9.2 Water Systems

The information in this section of the reference ABWR DCD, including all subsections, tables, and figures, is incorporated by reference with the following departures and supplements:

Figure 9.2-9 Potable and Sanitary Water System (Sheet 1 of 2)

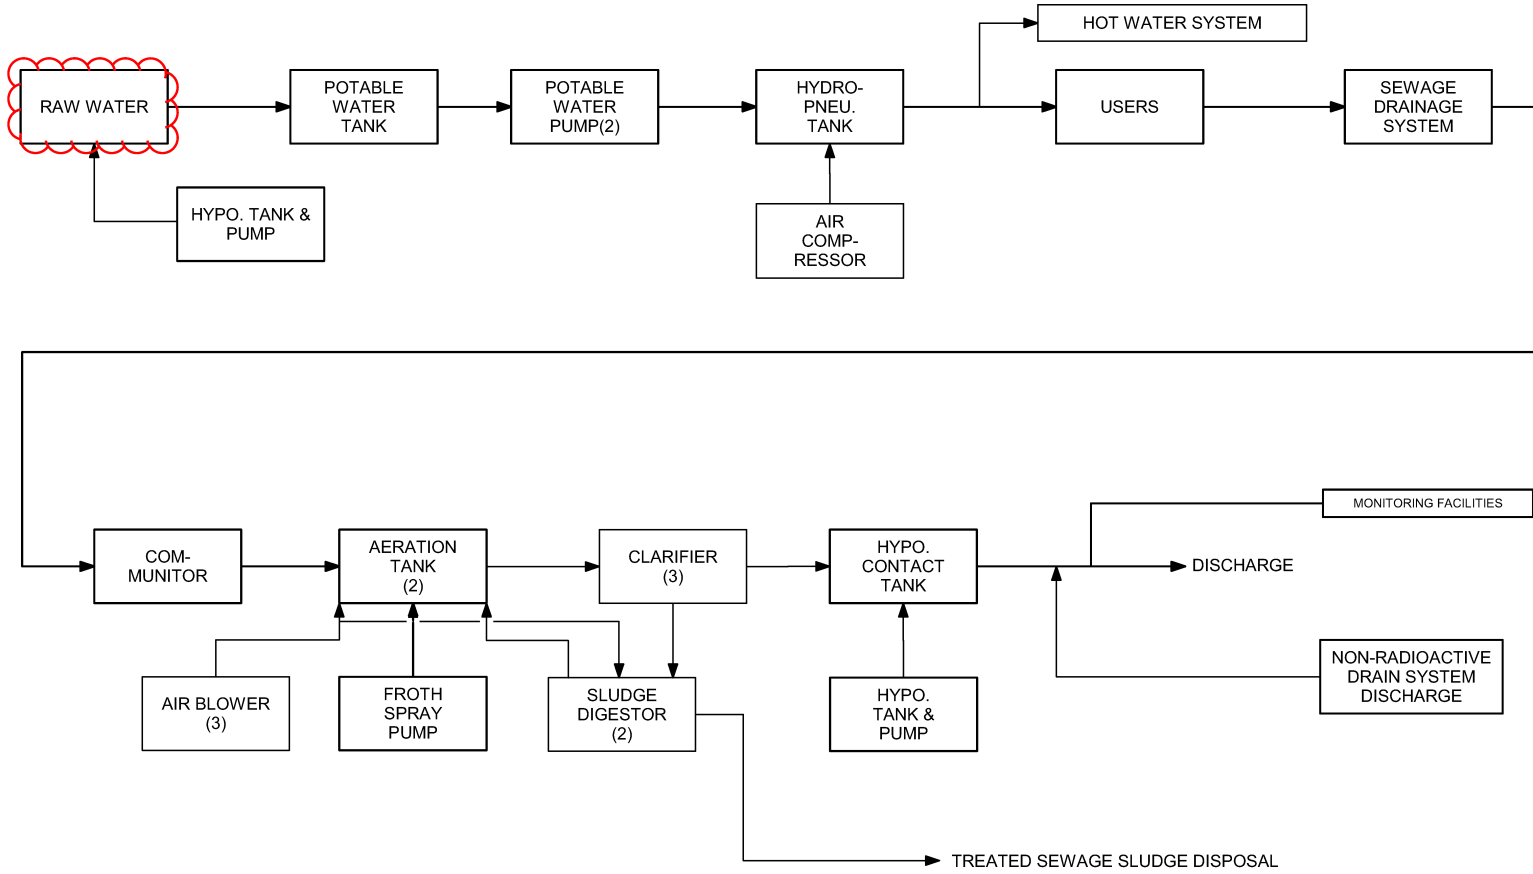
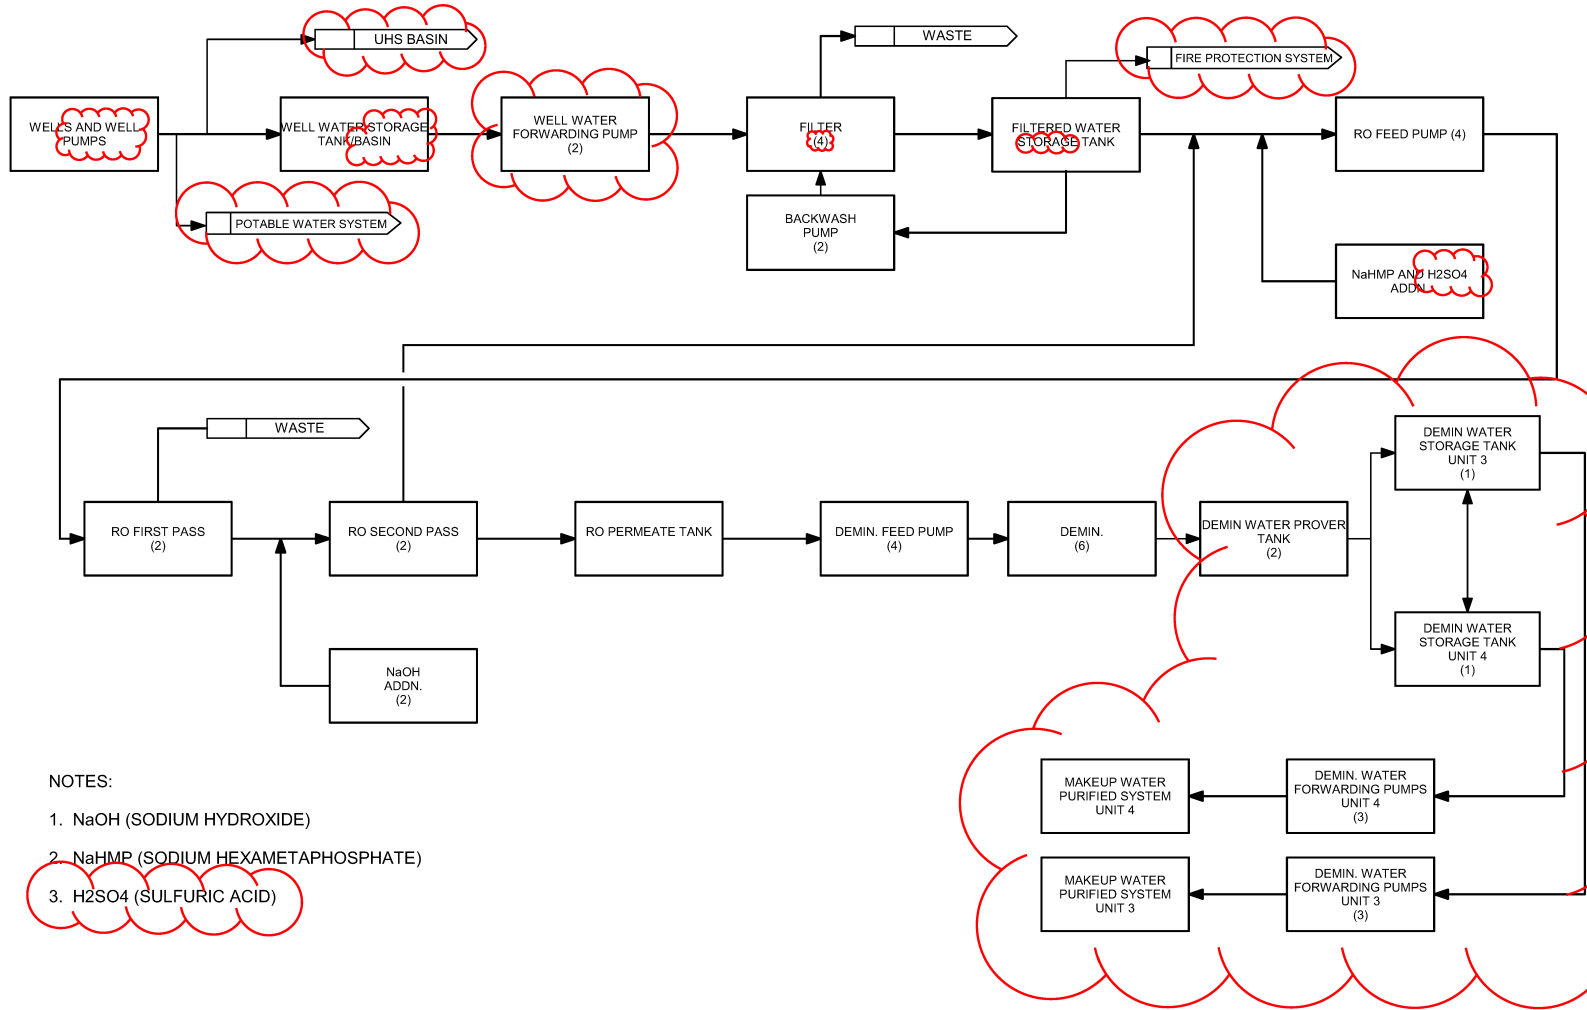
STP DEP 9.2-8 (Table 9.2-14 and Figure 9.2-9 Sheet 1 of 2)

STP DEP 9.2-8

- (1) *The PSW System is designed to provide to all buildings at STP 3 & 4 a minimum of ~~45 m³/h~~ 90 m³/h of potable water intermittently during peak demands.*
- (2) *Potable water will be supplied directly off of the well water system and is ~~filtered and~~ chemically treated to prevent harmful physiological effects on plant personnel.*
- (3) *The PSW System includes a sewage treatment system which treats sanitary waste for all four units at the STP site using the activated sludge biological treatment process. The aeration tanks are capable of receiving waste at a rate between ~~45 220~~ m³/d and ~~185 480~~ m³/d.*
